# SYDNEY MODERN CONCERNS: BRIEFING PAPER

10 October 2017

This paper discusses the growing concern about the Sydney Modern Project, its location and the process for public information and decision.

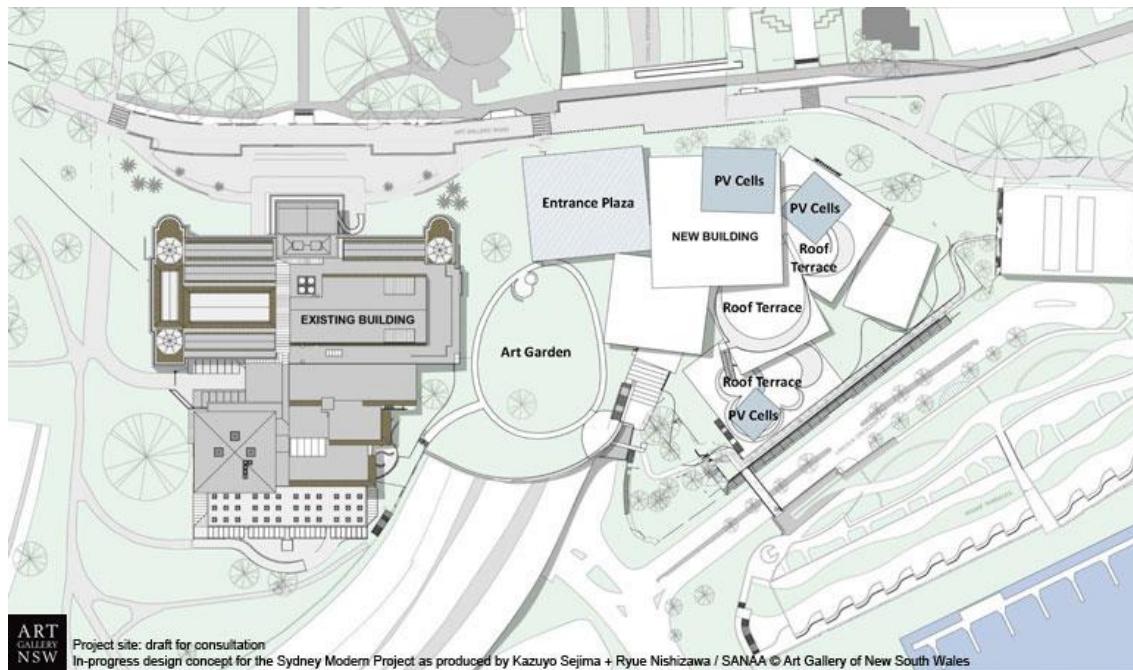
The Gallery has released a sketch drawing of the new design on this new location from a north east perspective.

The proposed building appears to occupy a footprint equal to or exceeding that of the existing Gallery buildings <https://www.artgallery.nsw.gov.au/sydney-modern-project/about/design-concept/>. In its new location, high on the grassy slope when viewed from Woolloomooloo, its size will be obvious and obtrusive. Until the Gallery recently updated its website, inquiries by the Friends have met with a response that details are not yet available~~s~~ as to the precise location, or dimensions and elevations of the building.

A newspaper report described the eight pavilions as ~~low-lying~~, but there is a significant drop from the land bridge level to the Fuel Tank Area, and without elevations or depictions of the building it is impossible to visualise the effect when viewed from the Domain or from below.
